# MEMORANDUM

To: Salt Lake City Planning Commission  
From: Trevor Ovenden, Principal Planner  
Date: March 27, 2024  
Re: 750 N Redwood Rd Planned Development Modification

**PROPERTY ADDRESS:** 750 N Redwood Rd  
**PARCEL IDS:** 08-27-452-049-0000  
**MASTER PLAN:** [Northwest Plan](#) (1992)  
**ZONING DISTRICT:** [Community Business](#) (CB)  
**PETITION:** PLNPCM2021-00702

**REQUEST:** Damian Mora, representing the property owner, is requesting several modifications to a previously approved Planned Development request. The original request was approved by the Planning Commission in December of 2021. After it was approved, the previous applicant sold the project to the current applicant. The current applicant redesigned the project with new architecture, fewer bedrooms, more parking, and two additional units. The modifications proposed by the current applicant require approval by the Planning Commission.

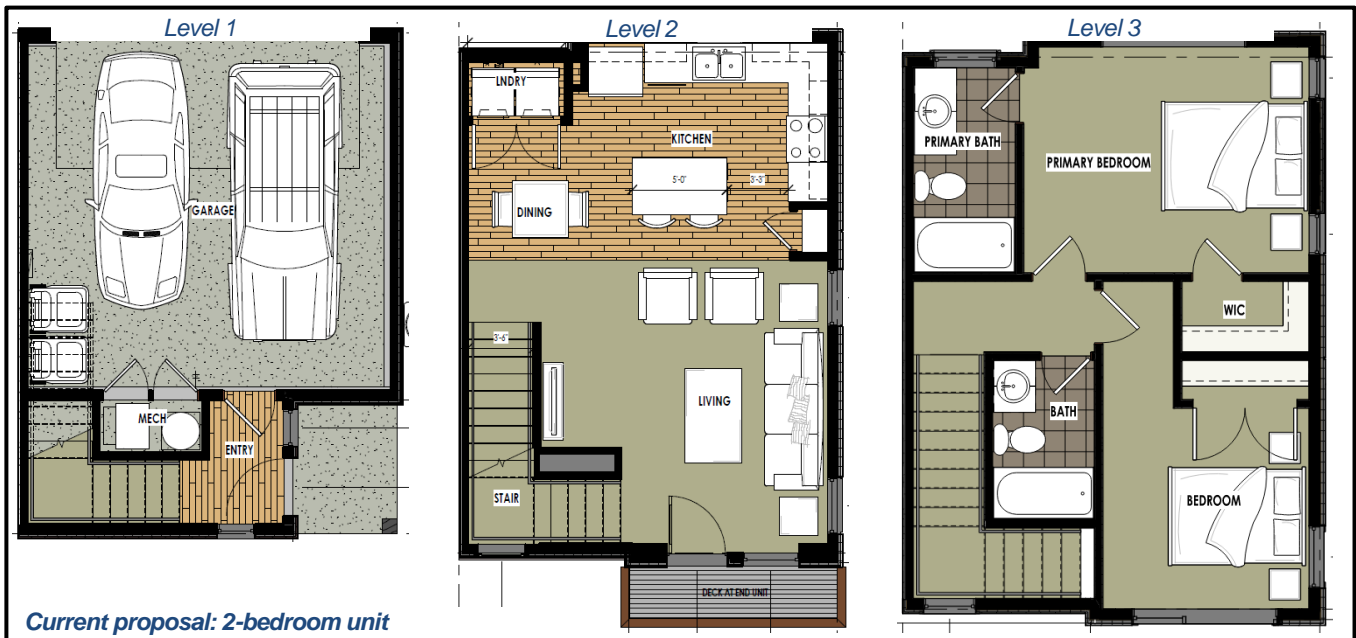
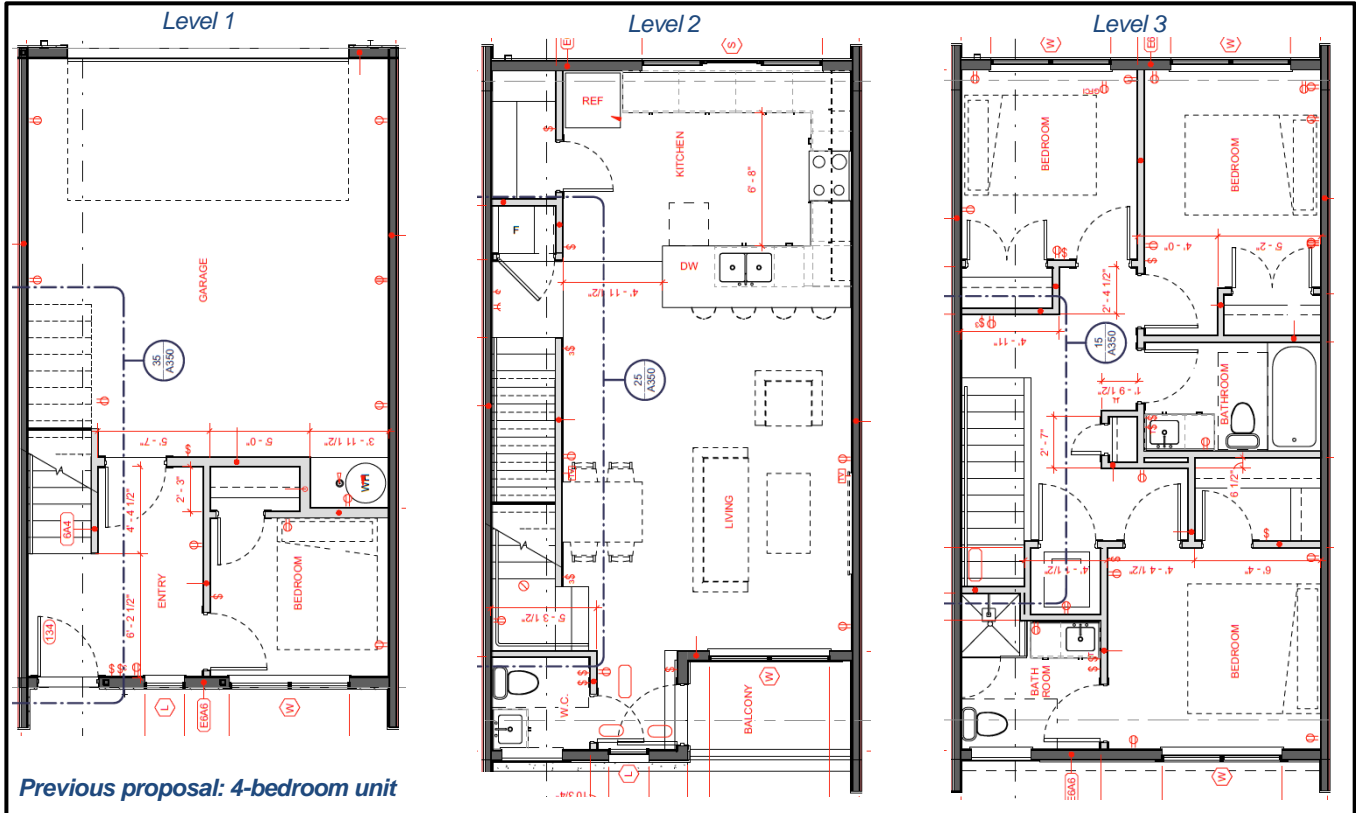
1. Different building design
2. An increase of units from 82 to 84
3. Replacing dumpsters with individual cans
4. An increase of parking spaces from 96 to 132
5. A reduction in bedrooms from 246 to 120
6. A change of ownership structure – Condominiums to rentals
7. An increase in space between buildings

The current proposal includes two additional units than the original. The new units will replace several guest parking spaces and the project's waste and recycling dumpsters (See [approved](#) and [modified](#) plans). The dumpsters will be replaced by individual cans that will be stored within each unit's garage. This proposal also includes 36 additional parking spaces than the original design. The new parking spaces are created by making the garages approximately 2' wider.

### Walkways

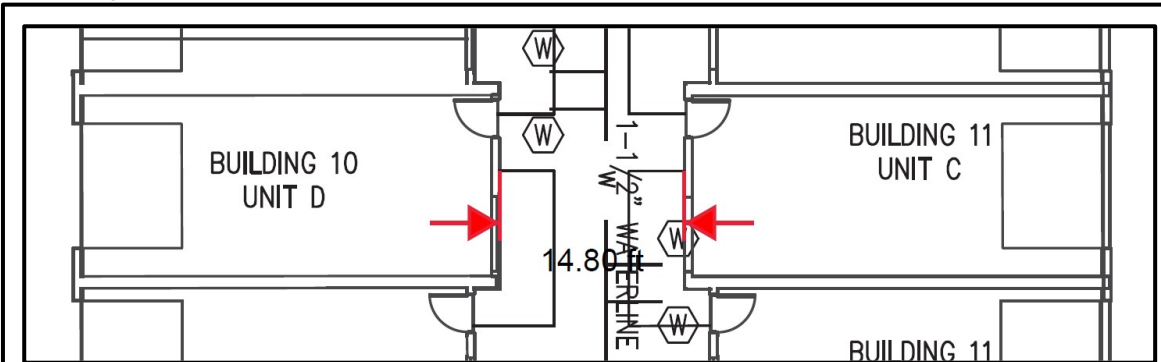
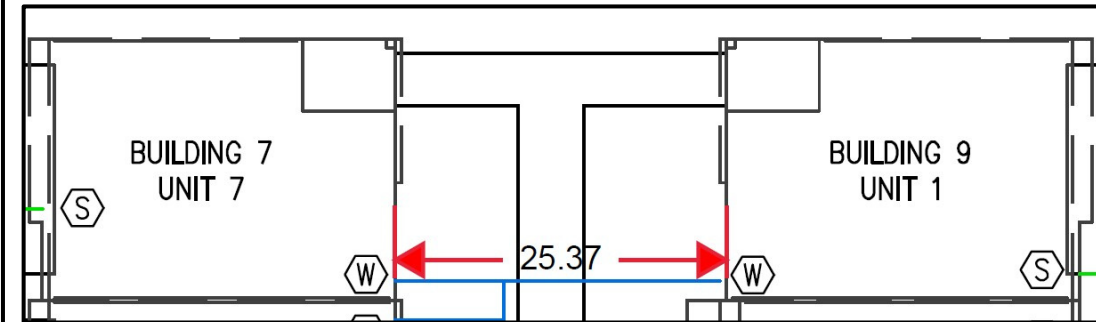
The new design also includes several dimensional modifications to create more space between buildings and units with fewer but larger bedrooms. The distance between buildings will be increased by approximately 10'. Driveways have been added to each garage that are between 4' and 5' long.

### Driveways

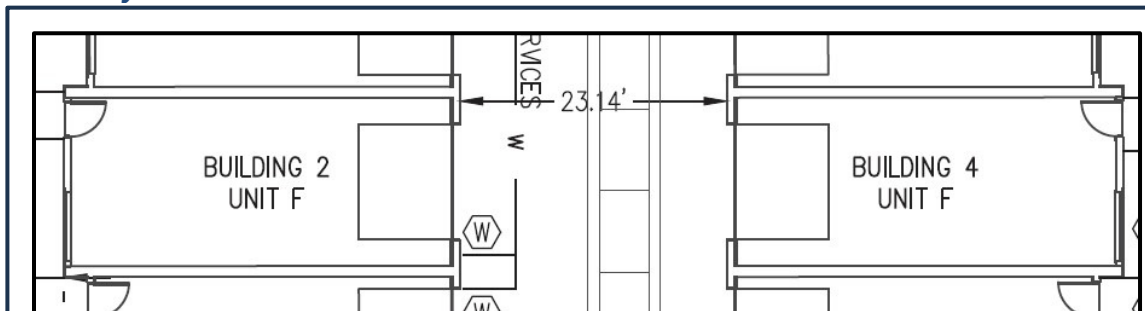
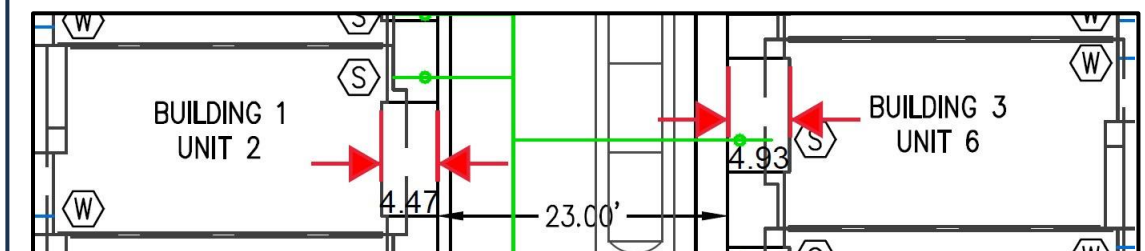
Two units added, one at end of each building.

## Dumpster

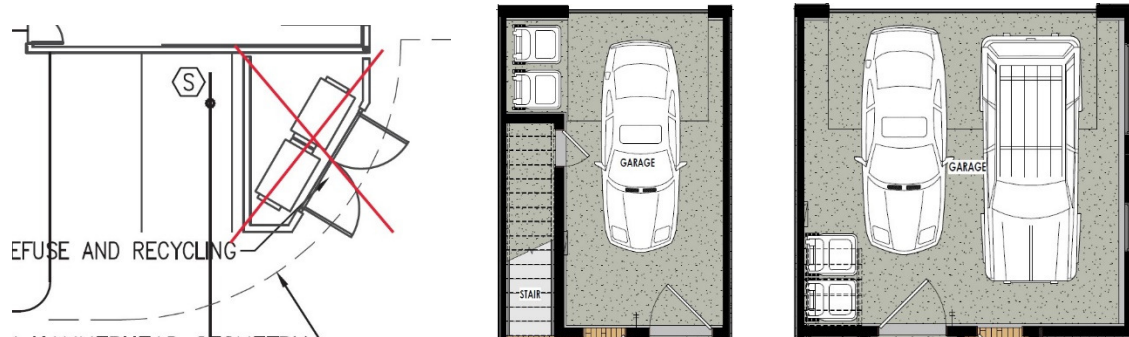
We removed the central garbage and recycling dumpsters and replaced with individual garbage and recycling bins for each home to be stored in the garage of each unit.

## Common Area

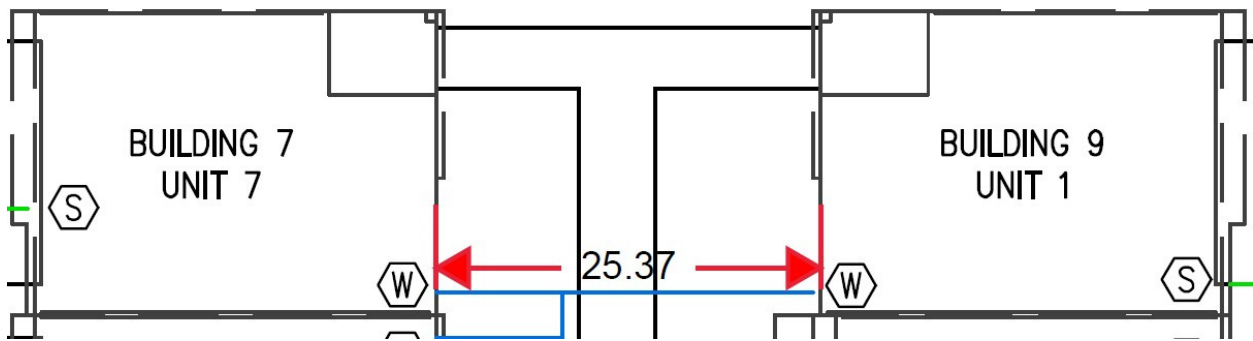
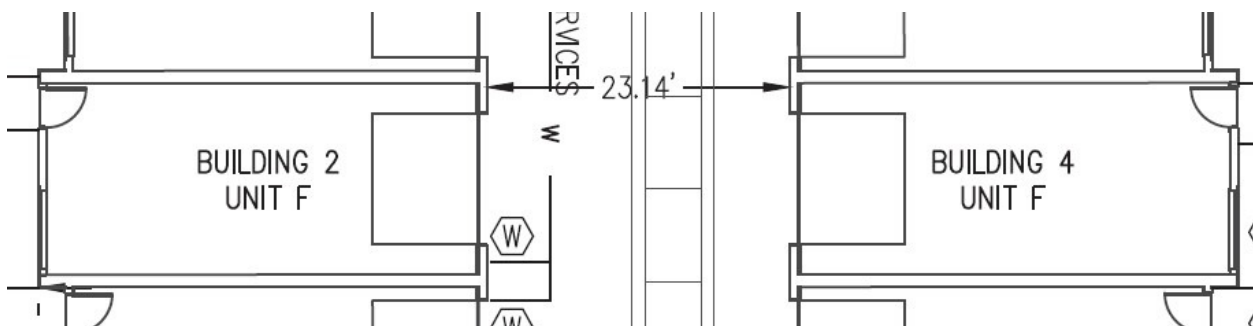
In the original design, the buildings are less than 15' apart in some areas, creating a cramped common area. With our modification the buildings are now at least 25' apart, face to face, creating a more usable and open common area.

#### Driveway/Private Road

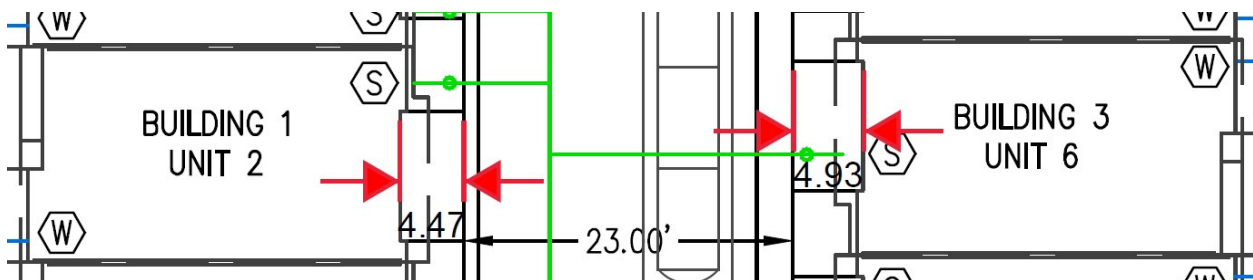
With the architecture update, we can provide more space between garages in the private road to allow vehicles to back out of garage easier and not run into the garage door across the road. We did this by providing a 4-5' driveway for each garage.
